June 10, 2024

Re: Austin Point – Water, Sewer, Drainage & Paving Improvements for The 1824 at Austin Point Section One - Variance Request
Fort Bend County MUD 239A
PD Job No. 41561-18

- Street Index W/ Map

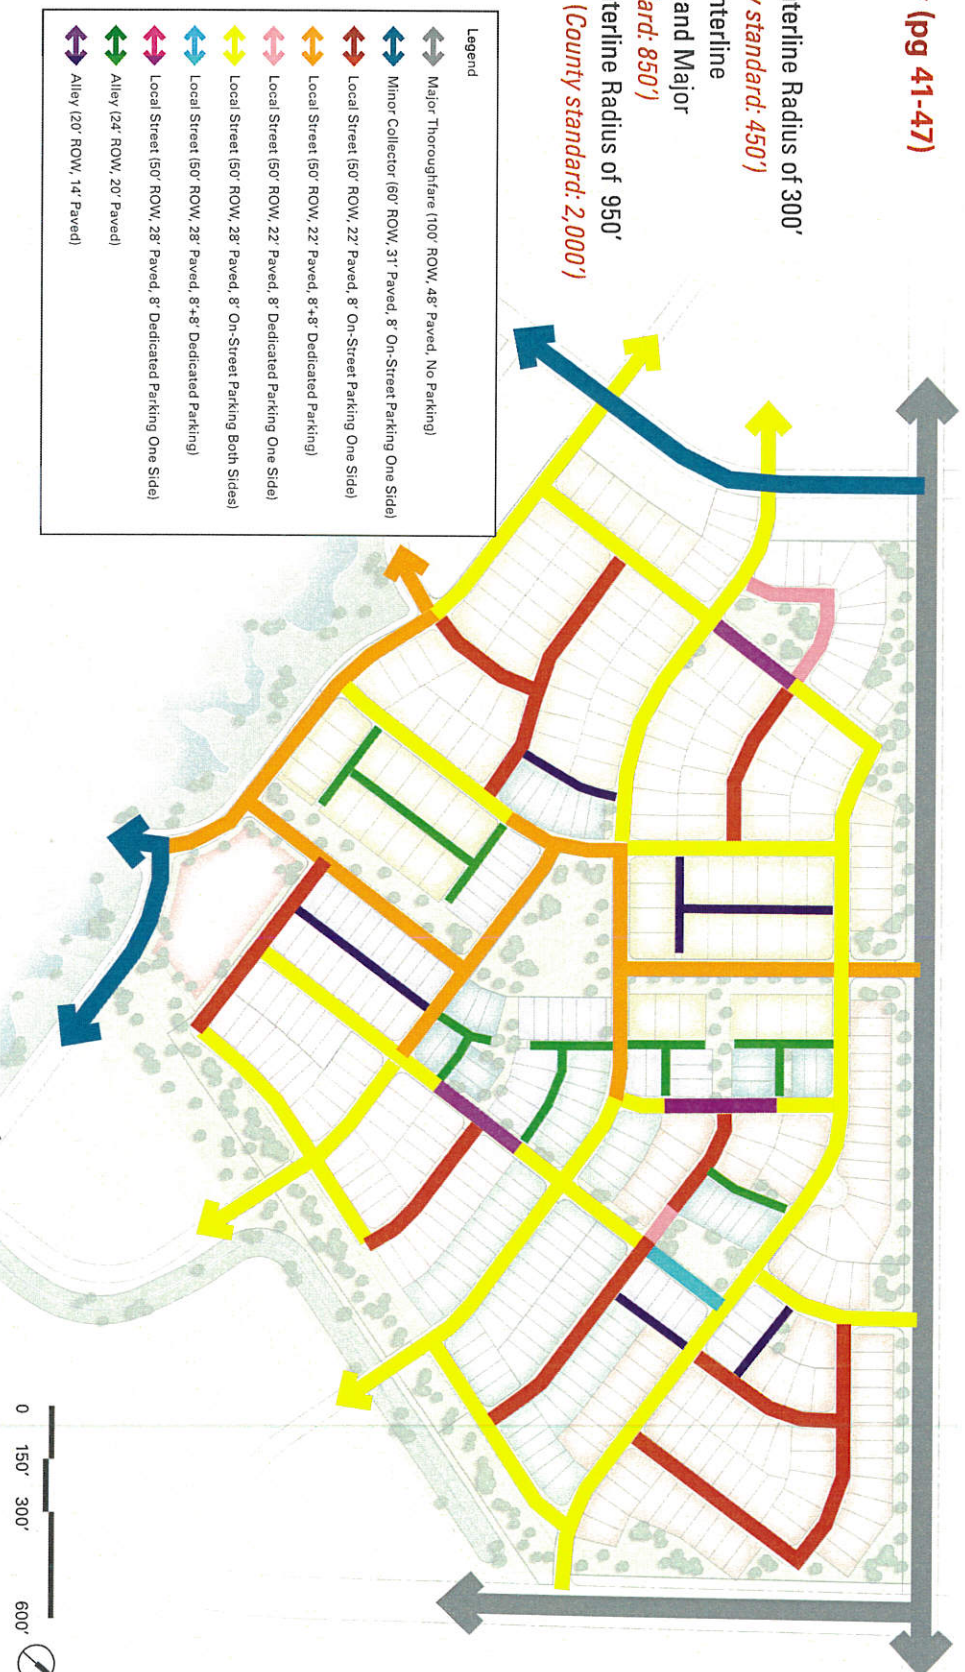
On behalf of Austin Point Development Company, LLC, A Texas Limited Liability Company we have submitted the construction drawings for The 1824 at Austin Point Section One to Fort Bend County for consideration and approval. We request a variance to the Fort Bend County roadway cross section standards of a minimum 28' B-B curb and gutter street with the following cross sections.

- Local Street: 50' ROW, 22' B-B Paving with 8' one-side parking.
- Local Street: 50' ROW, 22' B-B Paving with 8' dedicated one-side parking stalls.
- Local Street: 50' ROW, 22' B-B Paving with 8' dedicated parking stalls on both sides of roadway.
- Alleyway: 24' ROW (Dedicated by Reserve with a P.A.E / P.U.E.), 20' Paving
- Alleyway: 20' ROW (Dedicated by Reserve with a P.A.E / P.U.E.), 14' Paving

In addition, we would also request a variance from the Fort Bend County Standard of 25' Curb Radii to a reduced 15' Curb Radii for local streets.

In this section of development, the developer is proposing these variances in order to achieve overarching principles for the community as a whole. These variances will allow for slower traffic speeds and ultimately safer streets. They will also provide for an environment to bring livability and social connections through the means on streetscapes. Through the use of dedicated parking spaces with street trees, the developer is able to recapture the street space for the public realm by creating visual interest, bio-diversity and places to gather.
